Paper No. 6287

Engineering problems in recent river valley projects in India †

Kanuru Lakshman Rao, M.Sc., Ph.D., M.I.C.E.*Discussion*

FIG. 25.—COEFFICIENT OF DISCHARGE FROM $q = cd^{1.5}$ PLOTTED AGAINST INTENSITY OF DISCHARGE FOR DIFFERENT WEIR PROFILES AS OBTAINED UNDER FREE-FLOW CONDITIONS IN 1/40-SCALE MODEL OF HANUMANNAGAR BARRAGE GLACIS SLOPES

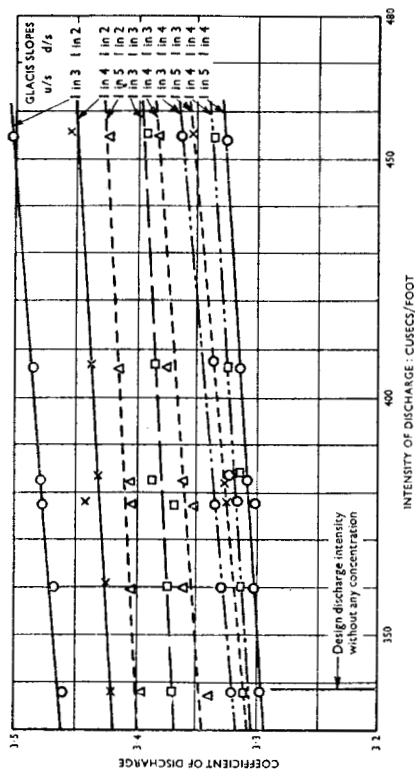
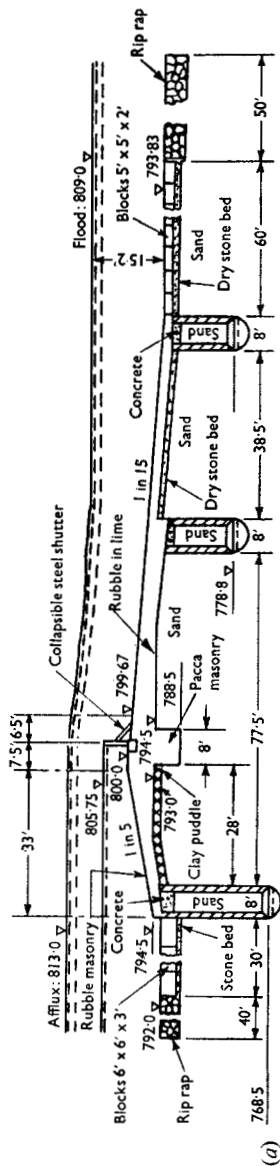
73a. In § 8 (iv) the Author went on: "Steeper up-stream and down-stream slopes of the glacis to improve discharge coefficient". He did not think it did improve the discharge coefficient. What it did was to fix the standing wave, and that, of course, was of vital importance.

136. The results of experiments on a hydraulic model of Hanumannagar Barrage across the Kosi River were summarized in Fig. 25 and it could be seen that the discharge coefficient could be improved by suitable upstream and downstream glacis slopes.

FIG. 26.—CORRECTED PROFILES OF MARALA WEIR (SEE FIG. 3) (a) ORIGINAL (1880); (b) BEFORE RECONITIONING (BAYS NOS 1 TO 6); (c) AFTER RECONITIONING

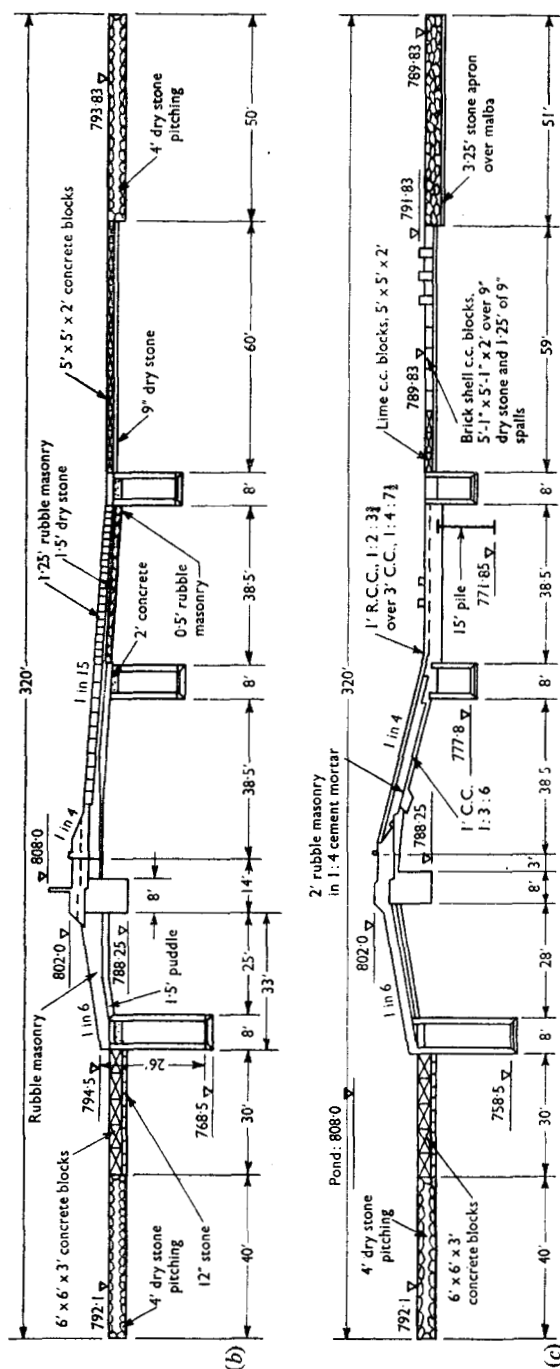
74. Mr Montagu had been personally connected in one capacity or another with some of the weirs illustrated in Figs 3a, 3b, and 3c. In the diagram of Marala Weir, which showed bays Nos 1-6 before reconditioning (Fig. 3a), the dimension from the downstream face of the upstream row of wells to the upstream face of the crest wall was 33 ft. In the diagram of Marala Weir after reconditioning (Fig. 3a) it was shown as 28 ft. Also, the distance between the upstream face of the crest wall to the face of the baffle stone which held the falling shutters was marked in the upper diagram as 14 ft and in the lower diagram as 8 ft and 3 ft, a total of 11 ft.

75. One of the diagrams was marked "Marala Weir before reconditioning" and the other "After reconditioning", but the third diagram in Fig. 3b was marked merely "Marala Weir". There the dimension from the downstream face of the upstream wells to the upstream face of the downstream wells was shown as 70 ft. Taking the totals on the two other diagrams, he found that they came to $85\frac{1}{2}$ ft and $77\frac{1}{2}$ ft respectively. He was not aware that any of the wells had been moved when reconstructing the weir.

137. The Author did not think that Mr Montagu's criticism of the accuracy of the drawings was relevant to the discussion. He had, however, checked them carefully and had found a few errors. Fig. 26 gave the corrected forms of the cross-sections of Marala weir (see Figs 3a and 3b).

FIG. 27.—KOSI RIVER AT HANUMANNAGAR. SILT DATA FOR AUGUST AND SEPTEMBER 1954

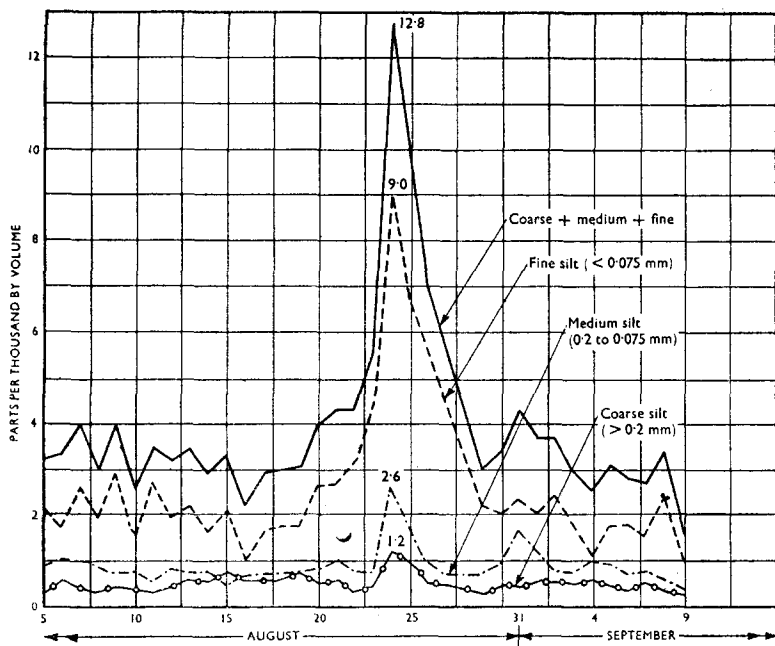
130. The Author stated that the River Kosi had shifted 75 miles during 60 years and also mentioned that barrages and embankments now constructed would control the rivers. It would, therefore, be assumed that the rivers under the controlled conditions would not shift and the economic life of these projects could be expected to be reasonably high. This should go a long way to provide relief to water tax. Could the Author provide some observed data with regard to the silt-load of the Kosi upstream and downstream of Hanumannagar Barrage.

161. Fig. 27 summarized the silt data of Kosi river at Hanumannagar for August and September 1954.
